SERVICE BULLETIN

Classification: BR15-001b	Reference: NTB15-047b	Date: June 25, 2015
------------------------------	--------------------------	------------------------

2014-2015 ALTIMA; BRAKE PAD WEAR ON RIGHT REAR ONLY

Figure 1

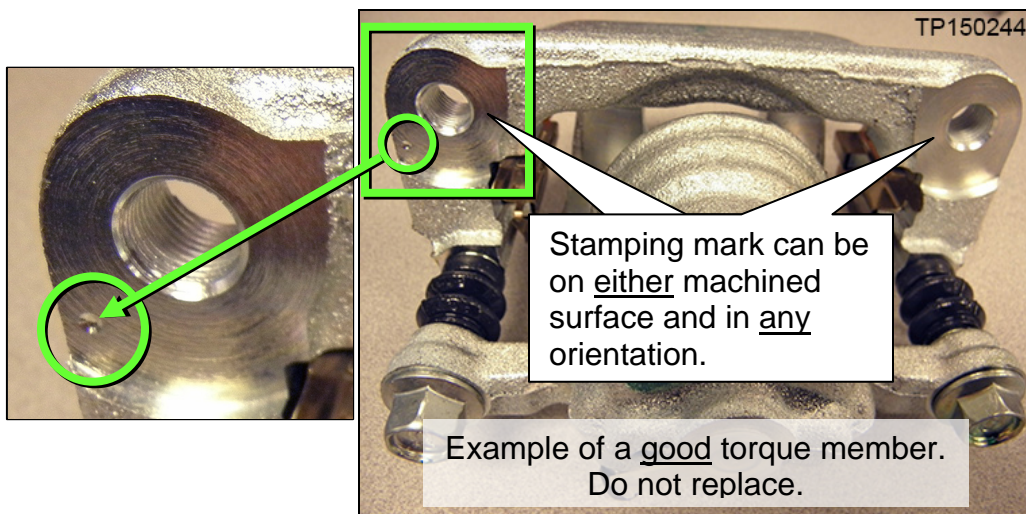
- There IS NOT a “stamping mark” on the Torque Member (shown and described in Figure 1, page 2).

NOTE: This stamping mark can be on either the right or left machined surface of the Torque Member.

This bulletin does not apply if stamping mark is present as described in Figure 1.

- Figure 1 shows a good Torque Member.

Replace the right rear brake caliper Torque Member and rear brake pad set with those from Parts Information; do not resurface rotors.

Figure 2

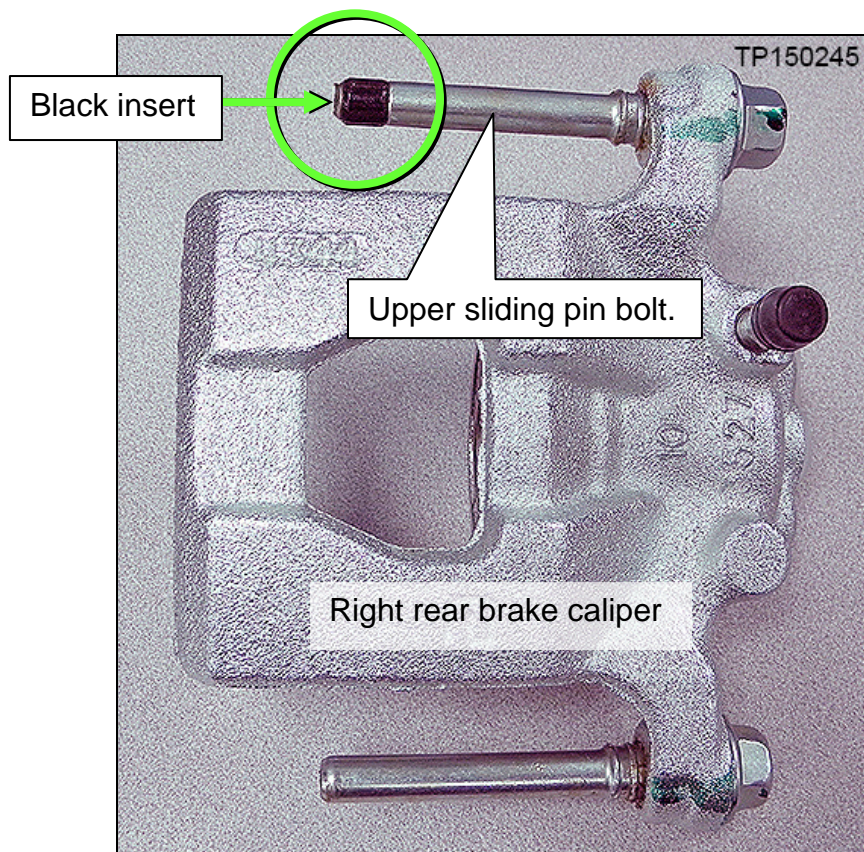
IMPORTANT: The upper and lower sliding pin bolts, that align the caliper to the Torque Member, are not interchangeable. When reassembling the caliper to the torque member, place the sliding pin bolt with the black insert (Figure 2, page 2) into the upper position.

- Figure 2 shows the correct orientation of the sliding pin bolts.
